Access Compliance Report

Public Rights-of-Way

(Curb Ramps)

Intersection ID: 14015	Main Street: LABURNUM_AV	Cross Street: ST_JULIEN_ST	Location: NW
ADA ID: F7C062523A68	Ramp Type: Perp	Initial Pass/Fail: Fail	Overall Compliance: No
Severity Score: 42.5			
Codes/Mitigation Info/Possible Solution		Field Measurements/Component Compliance

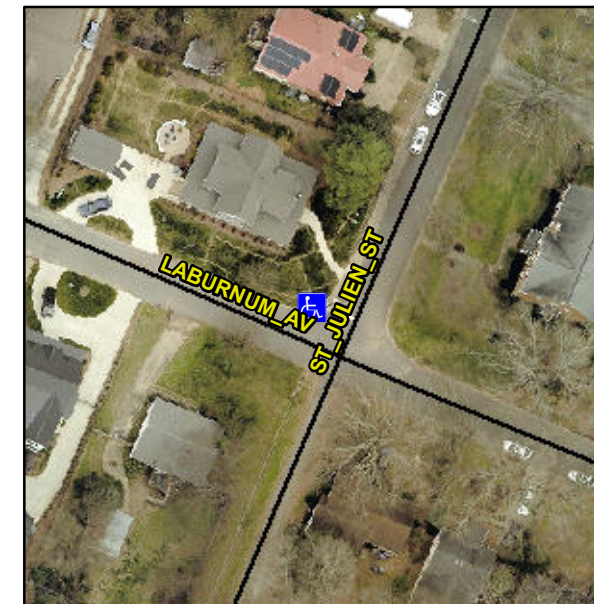
Not Found, R304.5.1, R304.2.2, R304.5.3

Compliance	Description	Data	Compliance	Description	Data
N/A	Ramp Length (in)	67.0	No	Ramp Slope (%)	9.3
No	Ramp Width (in)	32.0	No	Ramp XSlope (%)	6.2
N/A	Flare Type LT	N/A	N/A	Flare Type RT	N/A
N/A	Flare Slope LT (%)	N/A	N/A	Flare Slope RT (%)	N/A
N/A	Flare Traversable LT?	N/A	N/A	Flare Traversable RT?	N/A
N/A	Landing Length (in)	N/A	N/A	DWS Provided?	N/A
N/A	Landing Width (in)	N/A	N/A	DWS Contrast?	N/A
N/A	Landing Slope (%)	N/A	N/A	DWS Length (in)	N/A
N/A	Landing X Slope (%)	N/A	N/A	DWS Full Width?	N/A
N/A	Landing Curb? (Y/N)	N/A	N/A	DWS Offset (in)	N/A
N/A	Shared Landing?	N/A			
N/A	Gutter Ponding?	Yes	N/A	Gutter Slope (%)	N/A
N/A	Gutter Lip Ht (in)	N/A	N/A	Gutter X Slope (%)	N/A
N/A	Painted X Walk1?	No	N/A	Painted X Walk2?	N/A
	X Walk 1 Direction	To SW		X Walk 2 Direction	N/A
N/A	X Walk 1 Width (in)	N/A	N/A	X Walk 2 Width (in)	N/A
	X Walk 1 Slope (%)	1.2		X Walk 2 Slope (%)	N/A
	X Walk 1 X Slope (%)	3.5		X Walk 2 X Slope (%)	N/A

Remove & Replace Entire Ramp.
